APPLICATION NO.	FILING DATE	FIRST NAMED INVENTOR	ATTORNEY DOCKET NO.	CONFIRMATION NO.
10/698,867	10/30/2003	George Paskalov	100798.0008US1	2026
24392 7590 01/15/2008 FISH & ASSOCIATES, PC ROBERT D. FISH 2603 Main Street Suite 1050 Irvine, CA 92614-6232			EXAMINER WONG, EDNA	
			ART UNIT 1795	PAPER NUMBER
			MAIL DATE 01/15/2008	DELIVERY MODE PAPER

Commissioner for Patents**RE: REPLY BRIEF**

Response to Appellant's Reply Brief

FIG. 1

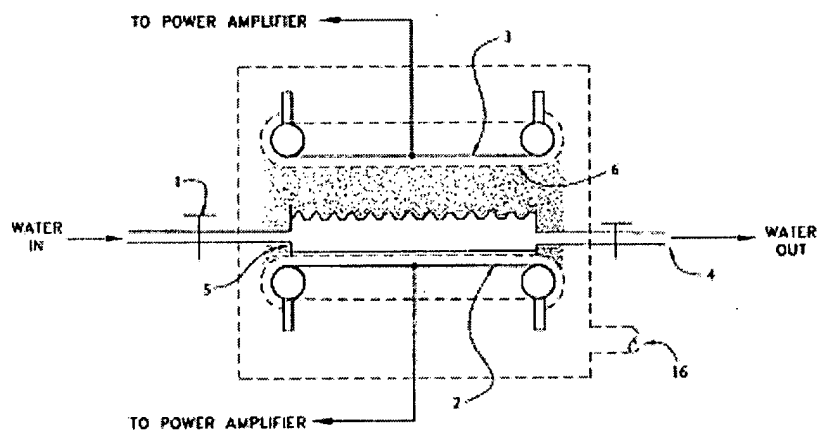
Applicants state that looking at Fig 1 of Laroussi, the water (labeled 110) is directly subjected to the plasma (labeled 120). Additionally, reference character 5 does not show a “closed container” as the Examiner argued. (See Supplemental Examiner's Answer P 8) The top of the container is obviously open, as shown by the waves of plasma 120 entering the top of the container.

In response, Laroussi shows in Fig. 1, a particulate shaded region which is the plasma irradiation. The particulate shaded region does not go into the container 5 because the "water in" and "water out" space flow is clear of the particulate shaded region:

Thus, Laroussi teaches a closed container where Applicants' claim limitation of "without subjecting the waste directly to a plasma generated by the RF plasma wave generator" is met.
